**Torino Parc Planned Unit Development (PUD)  
 PUD Rezoning  
 P20-177**

**SUMMARY**

Applicant's Request:	PUD (Planned Unit Development) Rezoning for Torino Parc PUD to build 263 two-story townhouse units.
Applicant:	Engineering Design and Construction (EDC) / Bradley Currie, AICP
Property Owner:	St. Matilda, LLC
Location:	This property is located west NW East Torino Parkway, north of NW West Blanton Boulevard, and south of the C-105 canal.
Project Planner:	Holly F. Price, AICP, Senior Planner

**Proposed Master Conceptual Plan**

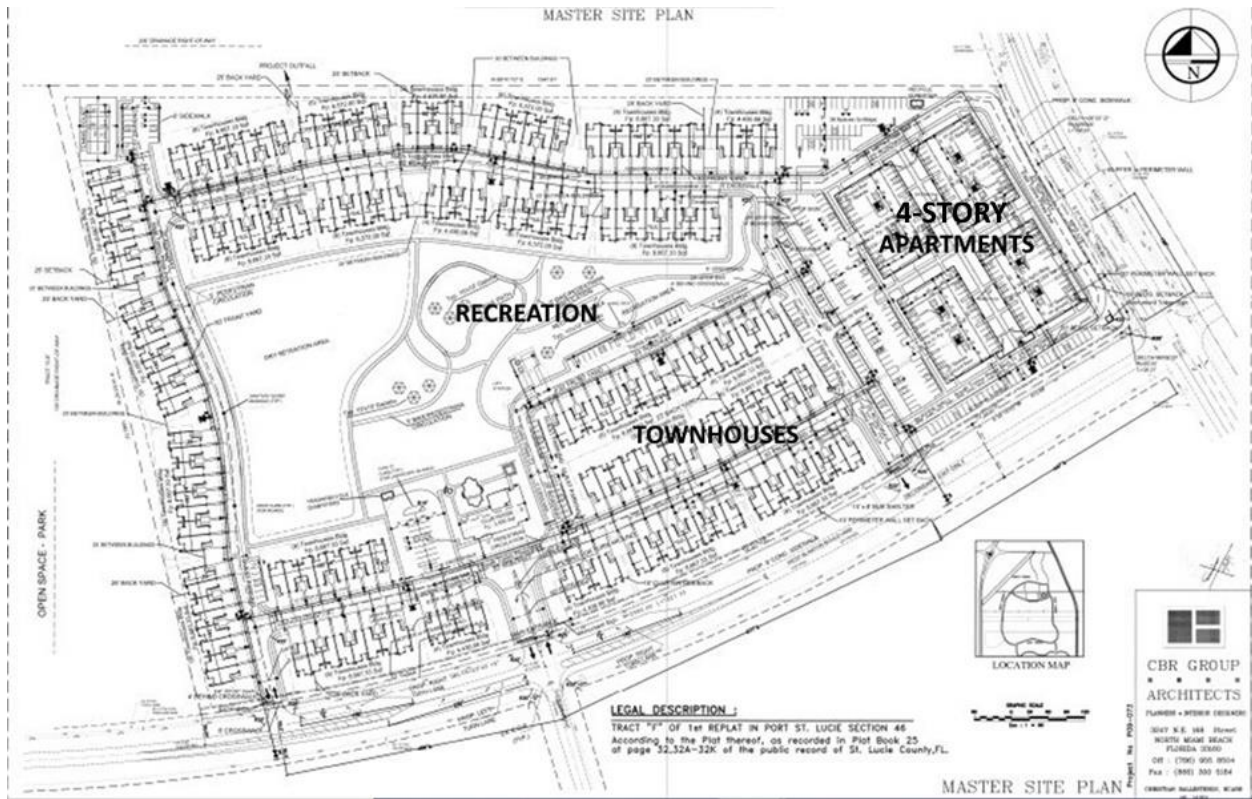
**Conceptual Master Plan:** The Conceptual Master Plan is included in the PUD document (and below).

However, the City has requested some mitigation improvements. The Conceptual Plan is showing the intention of constructing a left turn and right turn lane at the only entrance to the development on Blanton Blvd. and they are also proposing a right turn lane off East Torino Parkway to Blanton Blvd. In addition, the City plans to build a roundabout at the intersection of Turtle Dove Lane and East Torino Parkway in 2023.
